ECE/TRANS/WP.29/GRPE/57  
17 March 2009

**REPORT OF THE WORKING PARTY ON POLLUTION AND ENERGY  
ON ITS FIFTY-SEVENTH SESSION  
(13 – 16 January 2009)**

For an illustration of measurement parameters see [Figure 8/2](#) (below)

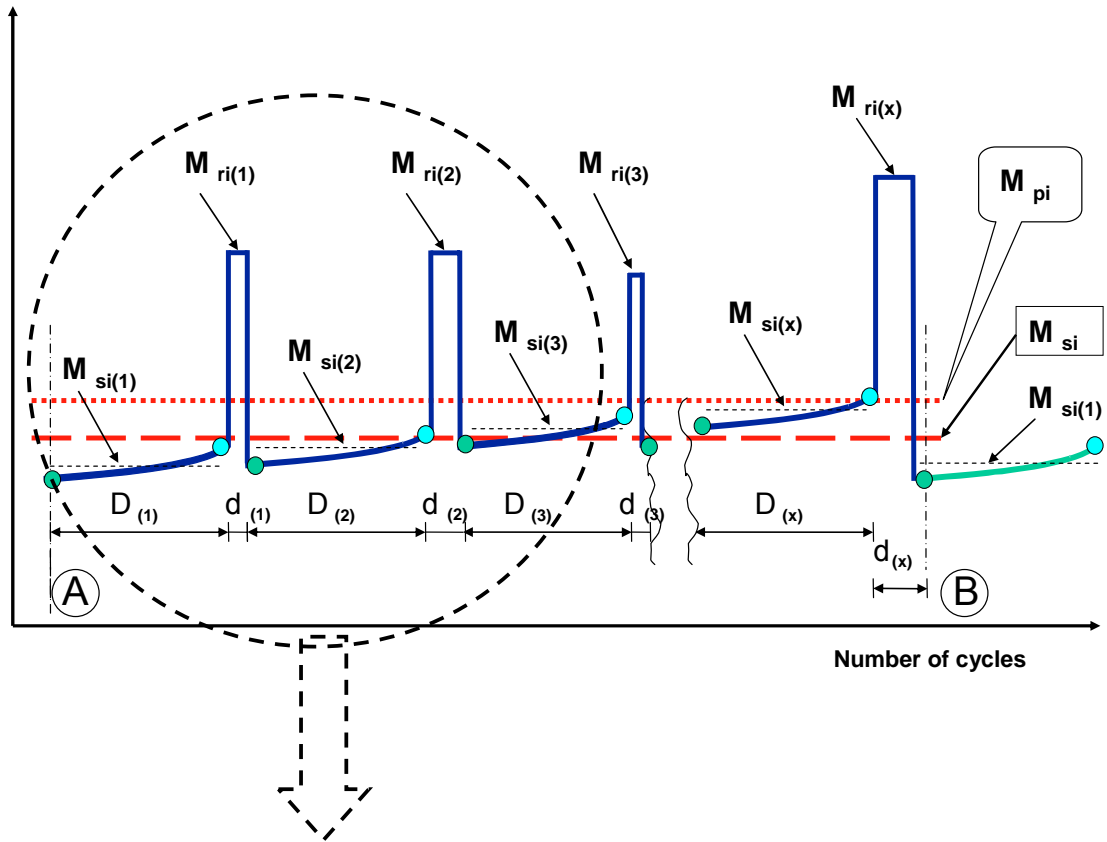
Page 6, paragraph 3.4., correct to read (switching the indices "j" and "k"):

**Figure 8/3:** Parameters measured during emissions test during and between cycles where regeneration occurs (schematic example)

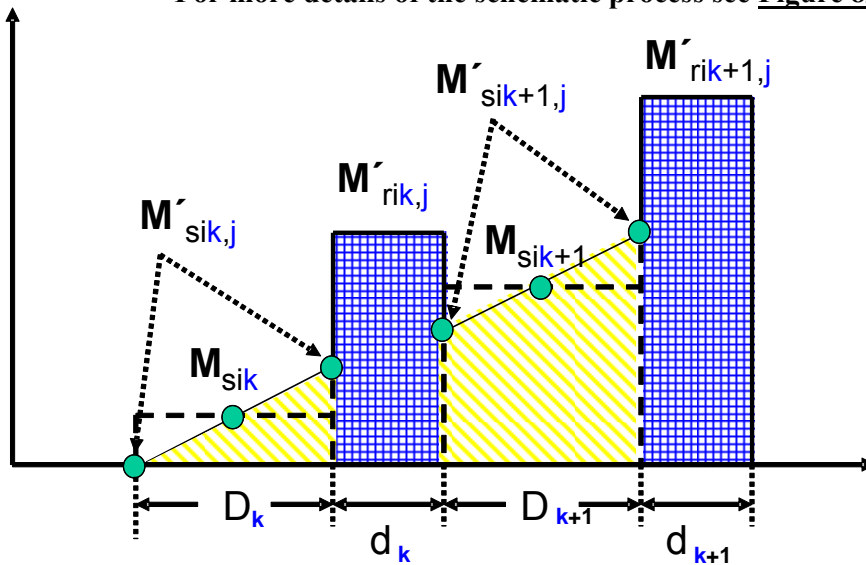
For more details of the schematic process see [Figure 8/3](#)

For application of a simple and realistic case, **the following description gives a detailed explanation of the schematic example shown in Figure 8/3 above:**
